#### STAFF REPORT

то	:	Allentown City Planning Commission
FROM :		Planning Bureau Jesus Sadiua, Senior Planner
SUBJECT	:	PROPOSED CAR STORAGE /WAREHOUSE BUILDING ON EAST CEDAR SREET

Project Title (Number): Eurosport Classic Motors (LMA-2022-00012)

> RE: 702 E. Cedar Street LMA-2022-00012

Fig-2. Project location relative to strategic areas identified in Allentown Vision2030.

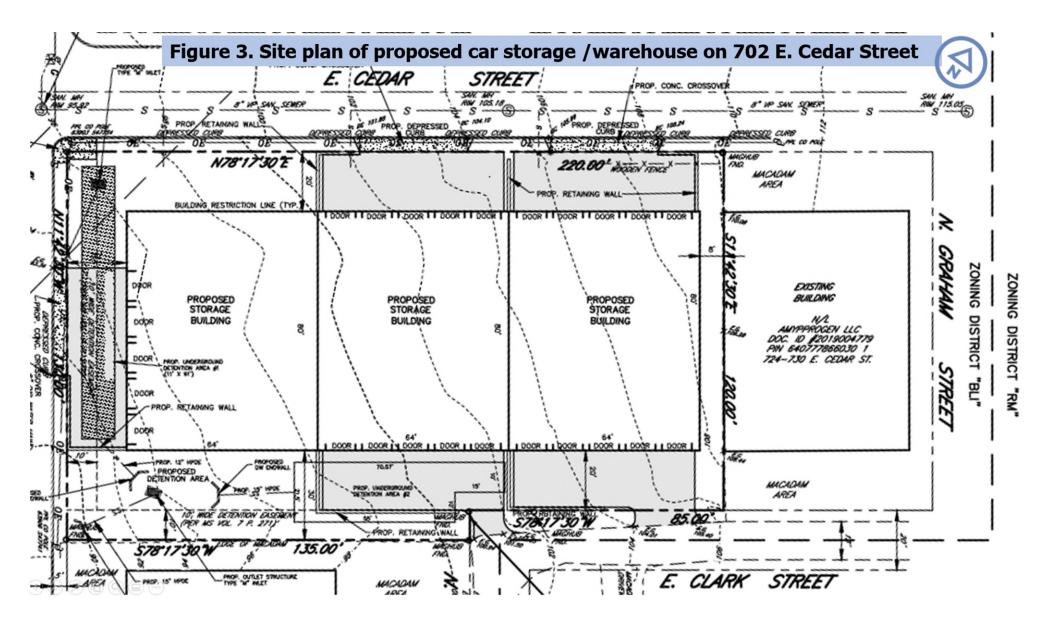
- 3. In any part of the city, Allentown Vision 2030 encourages the development of idle and under-utilized lands for productive uses. In this case, a vacant lot for a building storage with attendant amenities is an ideal land use option in terms of maximizing the use of land. The project site is between the major corridors of Union Blvd and Hanover Avenue (Figure 2).
